Johnson Controls Unitary Products
5005 York Drive
Norman, OK 73069

YS-SP007-15

Subject: 33" 80% & 90% Gas Furnace – Therm-O-Disc Limit Switch Recall

Issues: Suspect Limit Switch

Date code location on suspect limit switch

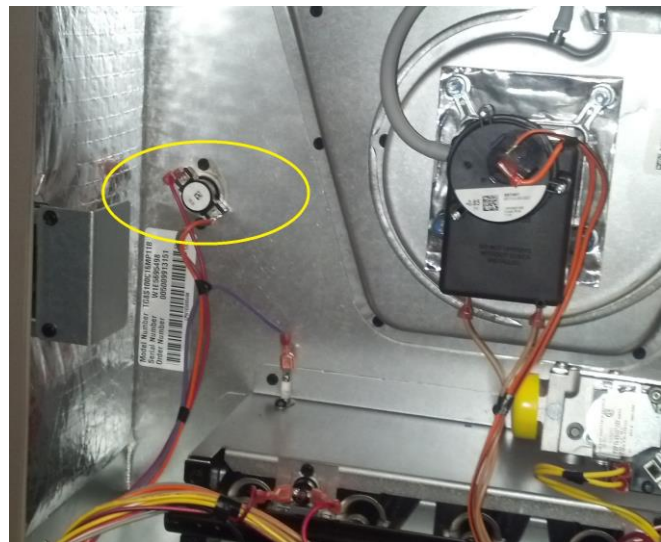
Below is a sample picture of the limit switch and where the date code is located. We also have pictures showing where the limit switch is located on both the 80% and 90% gas furnaces. Note that the limit switch on the 90% models is behind the gas valve.

Suspect units already installed must be remediated in the field by replacing the limit switch. This service letter provides a one hour labor allowance for replacement of any of the limit switch part numbers referenced above and which falls within the suspect date code range of 1511 through 1516. Make sure to reference this YS-SP service letter number on the claim.
